RE: **ADDENDUM NO. 1**

RE: ADDENDUM #1

Changes to Issue for Bid Documents Dated February 19th, 2026

PROJECT: RPS Project 2602 Carlson Elementary School Additions & Renovations

ENLARGED PLANS

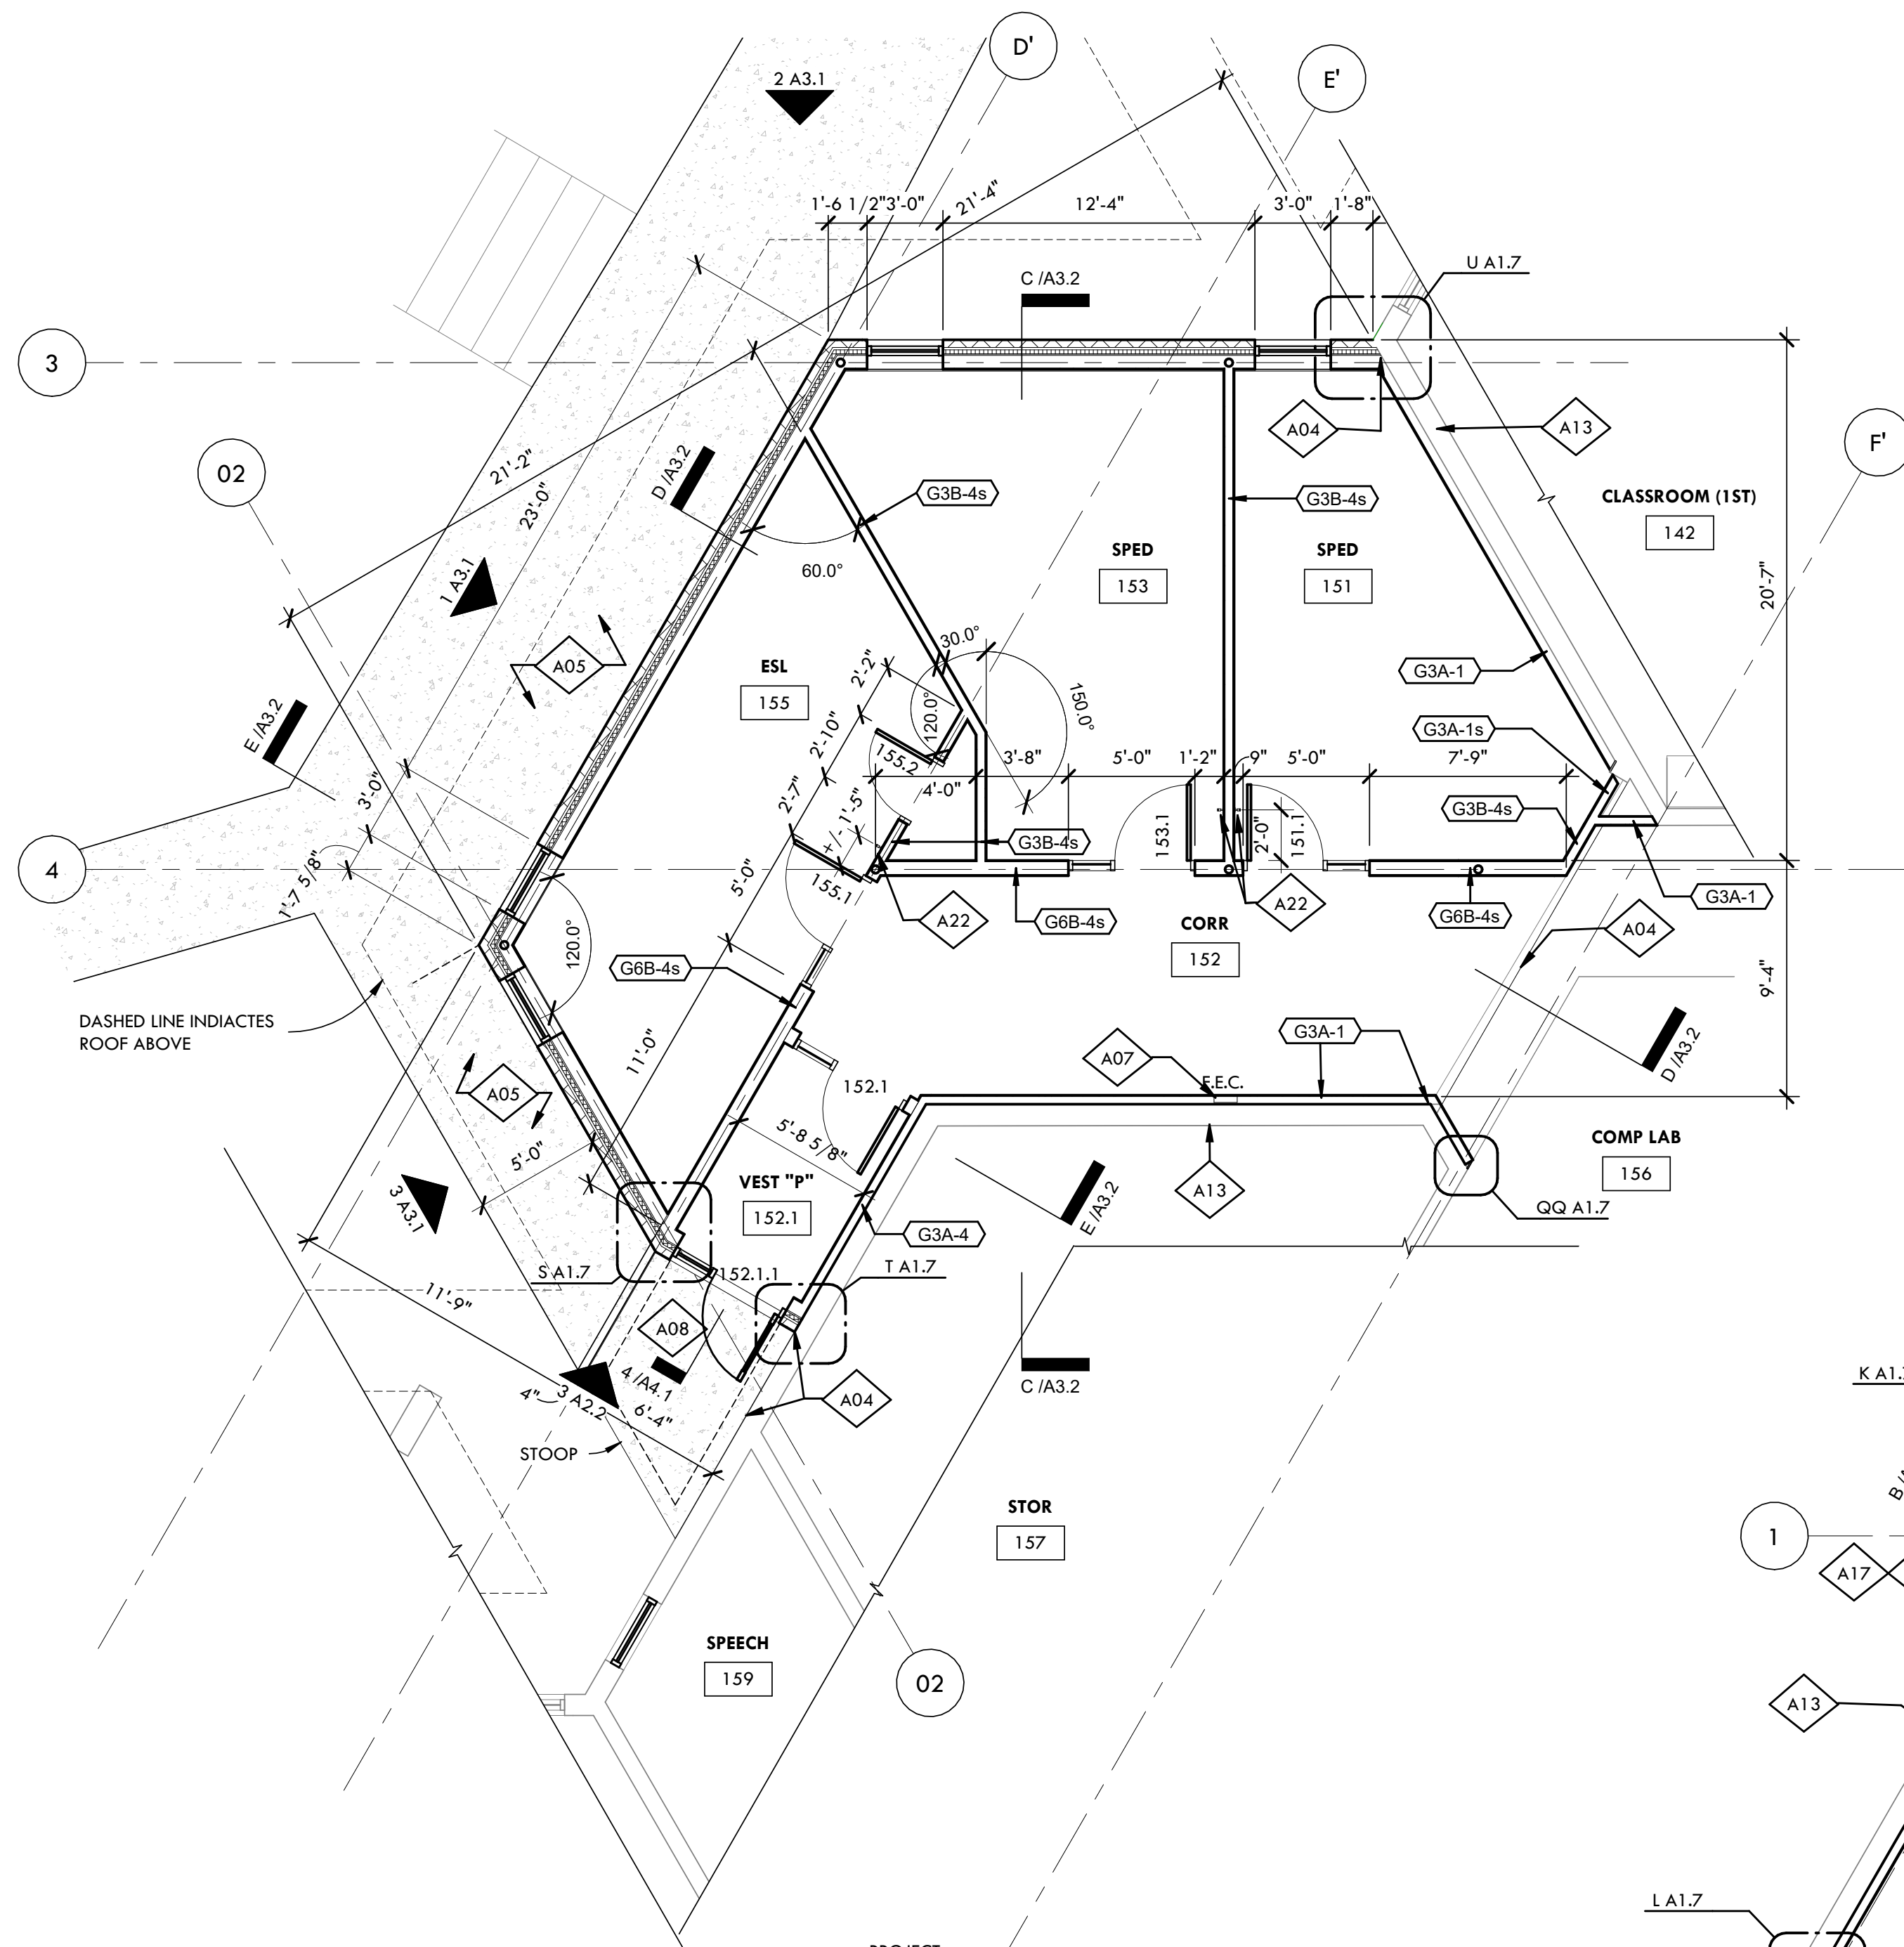
- A. Exterior door 126.1.1 and storefront 126.A have been added to the project.

EXTERIOR STOREFRONT TYPES

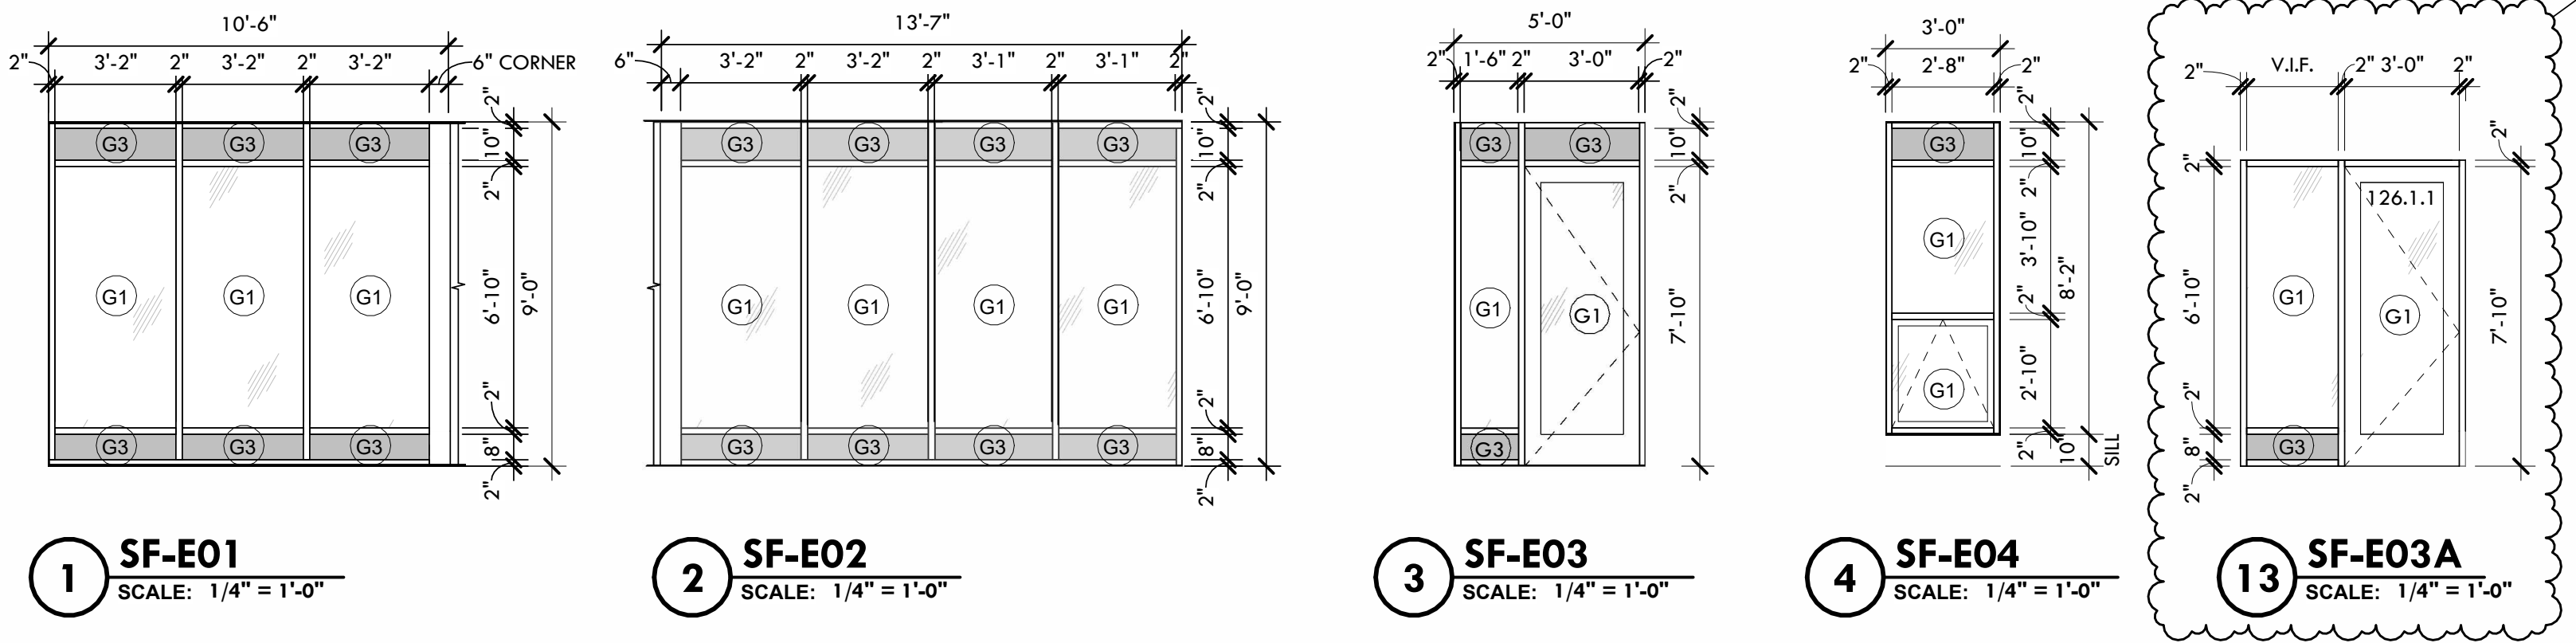
- A. Door 119.2 has been updated on the Door Schedule.
- B. Door 126.1.1 has been added to the Door Schedule.
- C. Storefront 126.1.A has been added to the Storefront Schedule
- D. Exterior Storefront Type 2-SF-E13 has been added to the project.
